ENCLOSURE I  
PROPOSED CHANGE NO. 117  
EXISTING TECHNICAL SPECIFICATIONS

ENCLOSURE II

PROPOSED CHANGE NO. 117

PROPOSED TECHNICAL SPECIFICATIONS

FIGURE 5.1.1  
EXCLUSION AREA

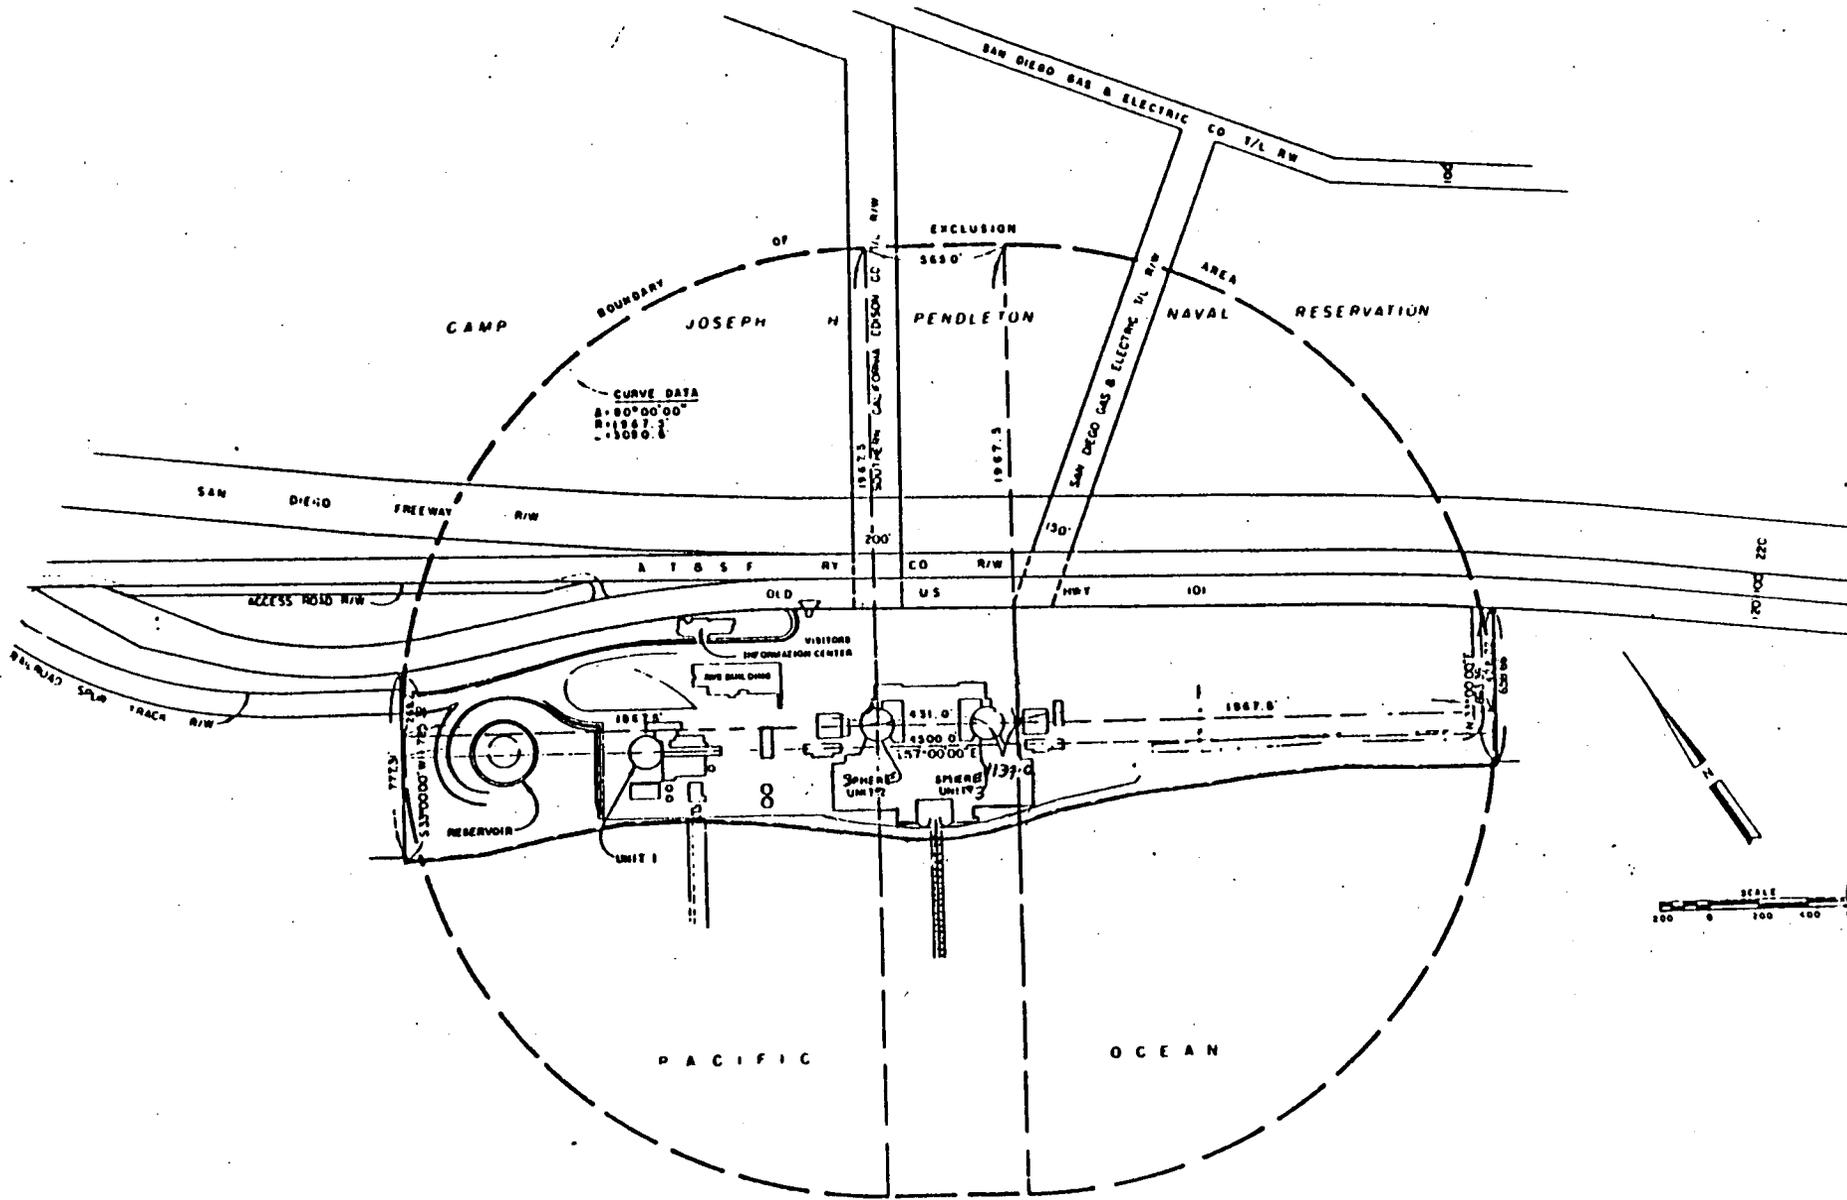
The San Onofre Nuclear Generating Station is located on the West Coast of Southern California in San Diego County, about 62 miles southeast of Los Angeles and about 51 miles northwest of San Diego. The site is located within the U.S. Marine Corps Base, Camp Pendleton, California. The minimum distance to the boundary of the exclusion area as defined in 10 CFR 100.3 shall be 283.5 meters from the outer edge of the Unit 1 containment sphere. For the purpose of dose assessment, a slightly reduced distance of 282 meters defined by the discontinuous line in Figure 5.1.1 is assumed.

Basis: Leasing arrangements with the U.S. Marine Corps provide that a minimum distance to the exclusion boundary will be 283.5 meters. All dose assessments are calculated assuming 282 meters.
